**Amendments to the Drawings**

### **Remarks/Arguments**

**FIG. 6**

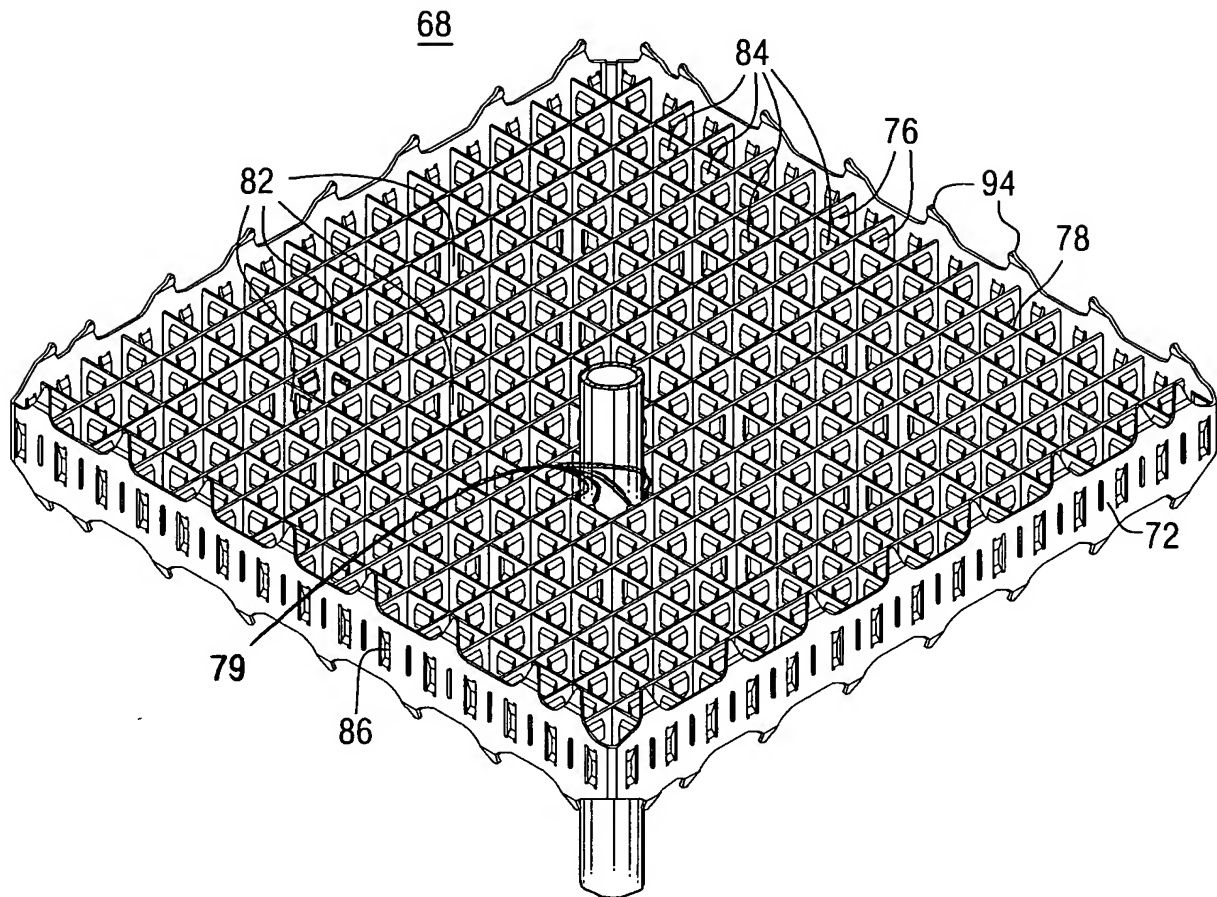
The attached sheet of drawings include changes to Figure 6. This sheet, which includes Figure 6, replaces the original sheet including Figure 6. In Figure 6, the welds that attached the control rod guide tubes to the grid cell are shown more pronounced by reference character 79. Support for this addition may be found on page 11, starting at line 9 et sec. Figure 6 has also been amended to better show that the springs in the grid cells that have springs, i.e., fuel rod support cells, are coplanar and are oriented in the vertical direction. Support for this clarification can be found on page 11, starting on line 5 and on page 11 starting on line 8.

In Paragraph 1 of the office action, the drawings are objected to under 37 CFR 1.83(a). The Examiner asserted that the drawings did not show every feature of the invention specified in the claims. More particularly, the Examiner asserted that the drawings did not show the relative size of the contact areas of the dimples and/or springs of the auxiliary support cells versus the main support cells. The Examiner also asserted that the features of Claims 9 and 13 were also not shown. The Examiner stated that he did not dispute that the drawings do not have to be drawn to scale. However, the Examiner asserted that the rules require that every feature recited in the claims, in this instance, the relative difference in size of the contact area of the dimples and/or springs of the inner straps of the two different grids, be shown. The Examiner concluded that none of the drawing figures illustrate the actual contact areas of any of the springs and/or dimples.

Applicants' attorney respectfully disagrees with the Examiner's position. However, for the sake of advancing prosecution, applicants have further amended Figure 6 to clearly show that the dimples and/or springs are on the vertical and they are all within the same plane. Addressing the relative dimensions, the Examiner's attention is directed to Figure 5, which clearly shows the springs on a diagonal with the contact area shown relative to the width of the cell as being substantially less than that shown for the vertical springs and dimples shown in Figure 6 relative to the cell wall width illustrated in Figure 6. The Federal Circuit in *Hockerson-Halberstadt Inc. v. Avia Group International, Inc.* (222 F.3d 951, 956, and 55 USPQ 2d 1487, 1491 Fed. Cir. 2000) stated: "It is well established that patent drawings do not define the precise proportions of the elements and may not be relied on to show particular sizes if the specification is completely silent on the issue." Thus, the court is acknowledging that the patent drawings do not have to show the precise proportions. Here, however, the specification does add to the drawings by clearly stating on page 11, starting at line 6, that the dimples and/or springs are co-planar, and on line 8, that the springs are on the vertical rather than on the diagonal. Starting at line 29, the specification specifically states: "The inner straps 76 and 78 on the auxiliary grids provide for a larger contact area between the dimple/springs and the fuel elements than are provided by the corresponding contact areas on the main support grids 46. The Court of Customs and Patent Appeals stated in *In re: Chitayat*, 408 F.2d 475, 161 USPQ 224 (CCPA 1969) that: Arguments based on mere measurement of patent drawings are of little value in absence of description in specification of relative dimensions. Here, we have both a clear statement in the specification and the

With regard to Claim 13, which calls for the auxiliary grids being maintained in the their axial position by being mechanically or metallurgically affixed to some of the guide tubes, reference character 79 has been added to Figure 6 to clearly show weld connections between the guide thimble and the grid straps. It is well known in the art that a weld creates a metallurgical connection between the welded members, and the references cited by the Examiner evidence that it is also well known to create a mechanical connection at that joint as a means of affixing the guide thimbles or sleeves that guide thimbles are attached to, to the cell walls. Figure 6 clearly demonstrates this principle and should now be acceptable. Accordingly, the removal of the objection to Claim 13 is also requested.

The Examiner asserted that the amendment filed 9/24/04 is objected to under 35 USC § 132 because it introduces new matter into the disclosure. The Examiner asserted that Figure 6 shows a 15 X 15 array, not a 17 X 17 array. Applicants fully agree. The earlier amendment was a typographical error. Figure 6 shows the 15 X 15 array and Figure 4 shows the 17 X 17 array. This further amendment has been made to the specification to correct this error.
